FERC Order 845 Second Compliance Filing Manual 14A / 14B / 14G Changes

Onyinye Caven
Interconnection Projects
Markets and Reliability Committee
August 20, 2020

FERC Order 845 Second Compliance Filing Tariff Changes

Section 1.9.1
Surplus Interconnection Request Process
 Sub-sections
 1.9.1.1-1.9.1.4

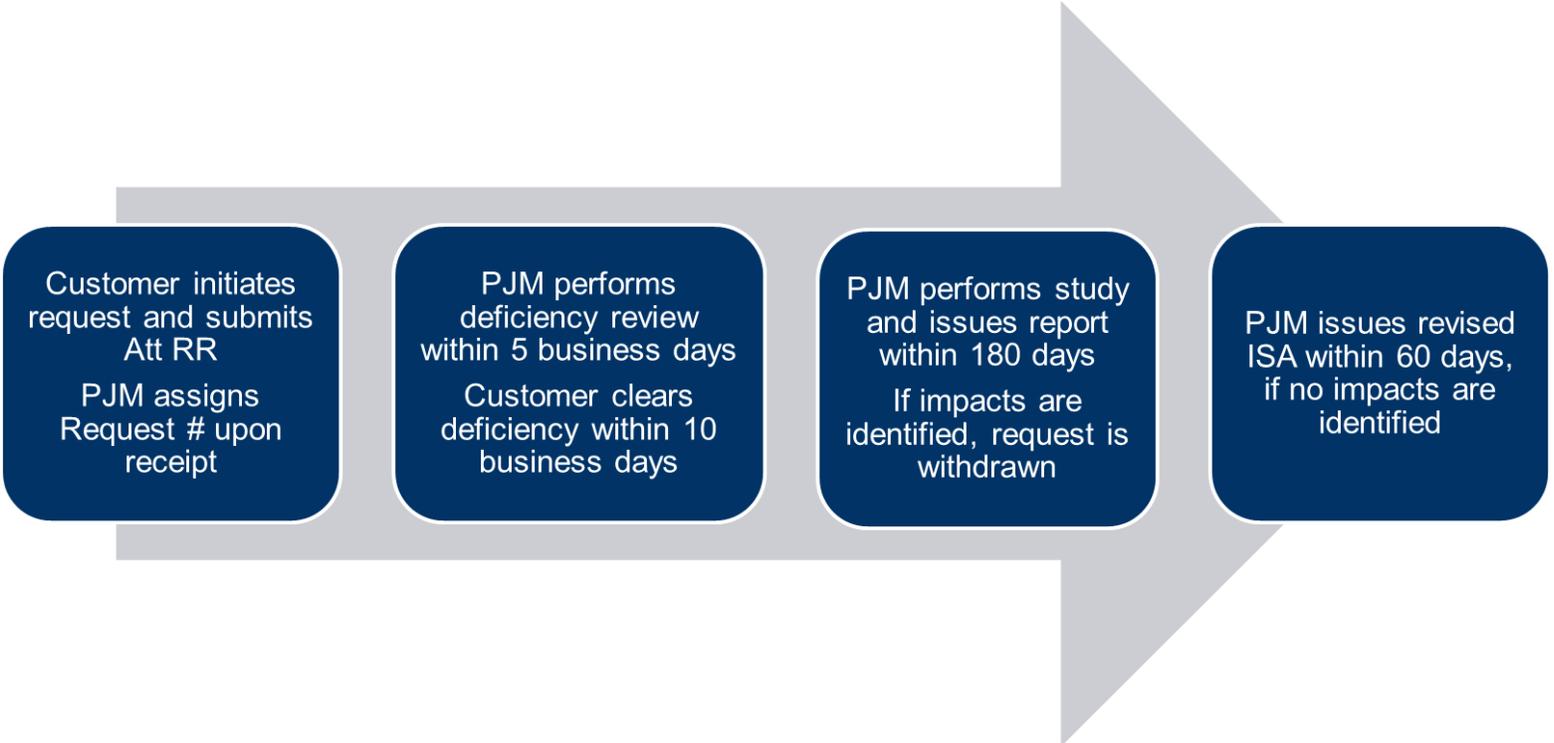
- Outlined Surplus Interconnection Request Process
